SITE PLAN REVIEW AND APPEARANCE BOARD STAFF REPORT

354 SE 5th Avenue - Waivers

Meeting	File No.	Application Type
November 30, 2022	2022-151-SPF-SPR-CLV	Class IV Site Plan
Property Owner		Agent
Delport Limited Partnership		Jeffrey Silberstein

Provide a recommendation to the City Commission regarding three waivers to the requirements of the Central Business District in association with a Class V Site Plan application to construct an 8-unit townhouse development.

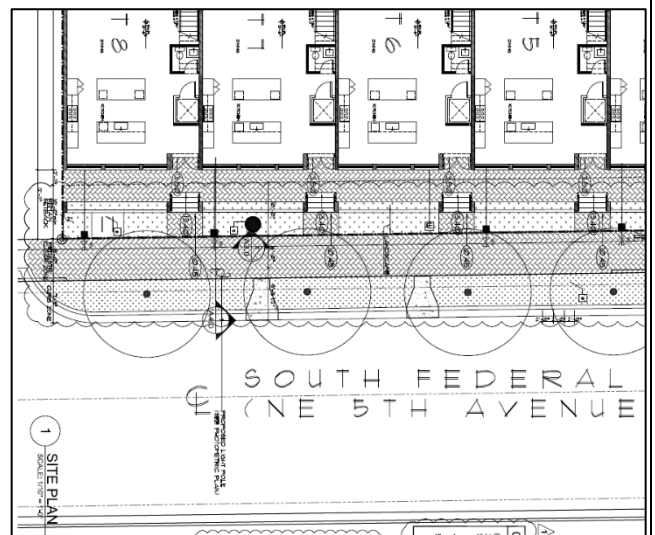
Regarding the waiver criteria, the Board should consider if the proposed omission of civic open space is directly at conflict with many of the findings. By way of eliminating the provision of civic open space, both the provision of public facilities (i.e. a public space) is diminished and the quality of civic open space is reduced. SE 5th Avenue is a primary street, and the diminishing of public facilities and reduction in the quality of civic open space along the street frontage will result in an inferior pedestrian experience along the street as compared to what would otherwise exist if the required civic space was provided. In addition, part of the Board's consideration is if the request to eliminate the required civic open space is a special privilege. There are no identified hinderances by the configuration of the land, only the proposed development design, that have necessitated the elimination of a civic open space. Therefore, the omission of civic open space should be considered a special privilege. Further, no waivers to allow the elimination of a required civic open space have been considered for any project within the CBD district since the adoption of the subject regulation in 2015.

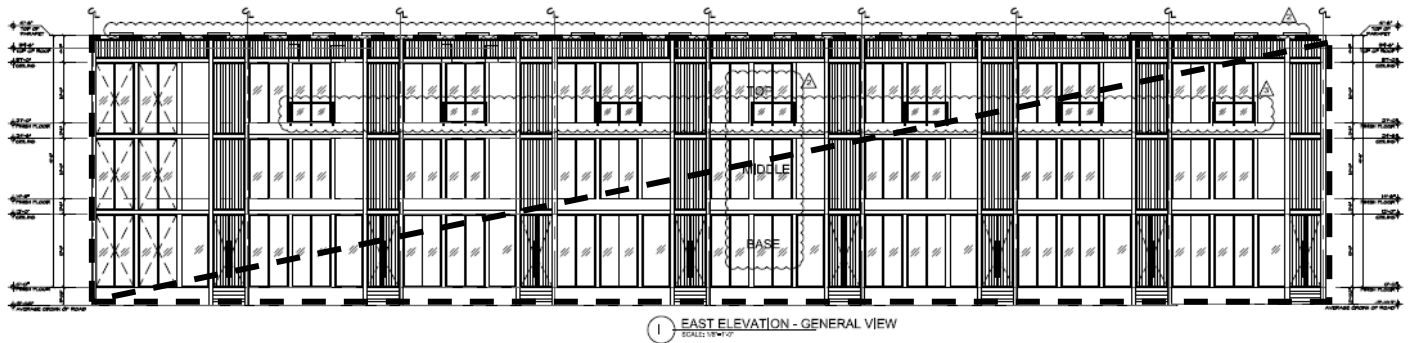
Allowing compositions absent of any differentiating articulation or design detail that breaks up the homogeneity of the massing, wherein the width of the façade exceeds the maximum ratios established as contextually appropriate, imparts a negative effect on the public realm wherein the heaviness and

repetition of structure appears out of scale and incompatible with established design and development patterns. The proposed design composition provides a homogenous repetitive façade that extends 204 linear feet, with a height of 41.5 feet, thereby equating to a ratio of five feet of width for every one foot of height.

The Board must consider if the request is inconsistent with the applicable findings given that the approval of the waiver would result in a primary façade that is out of scale with the historical and desired development pattern; emphasizes the heaviness of the massing and the structure's imposing relationship with the pedestrian realm, which are both deemed to be detrimental to the quality of the pedestrian experience along a primary street; and further constitutes a special privilege being that there is nothing unique to the property that precludes the applicant from adhering to the compositional requirements, which have been determined through the adoption of the CBD regulations to be appropriate and most successful in achieving a compatible scale of development.

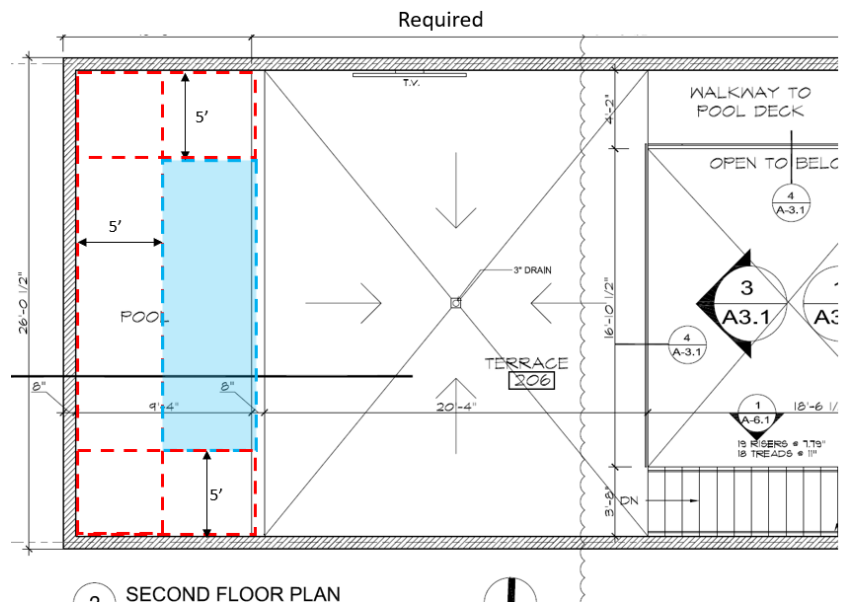
The applicant is proposing a pool configuration on the second floor of each unit that provides no setback on the sides and the rear of each pool, instead of the minimum 5-foot deck that is required around the perimeter of a rooftop pool. The only separation between each pool is a shared CMU wall. Should the waiver be approved, the pool design will still be obligated to comply with all applicable Florida Building Code requirements and any waiver approval would not supersede other applicable requirements. It is the responsibility of the Design Professional to ensure the proposed design complies with all applicable building codes at time of permitting.

It is important to note that the intent of the requirement to provide a five-foot wide (minimum) deck around the perimeter of a rooftop pool is generally based on safety precautions in that there is a clear and accessible means of ingress/egress from the pool area on all sides in the event an emergency were to occur. As proposed, the lack of egress on three of the four sides of the pool creates potential safety issues and is at conflict with the waiver criteria related to creating an unsafe situation. While handrails mounted to the side walls may be a potential strategy to mitigate the fact that there is no point of egress on three sides, the Board should consider whether providing a 5' deck on all sides of the pool creates an environment that is safer than the configuration proposed.
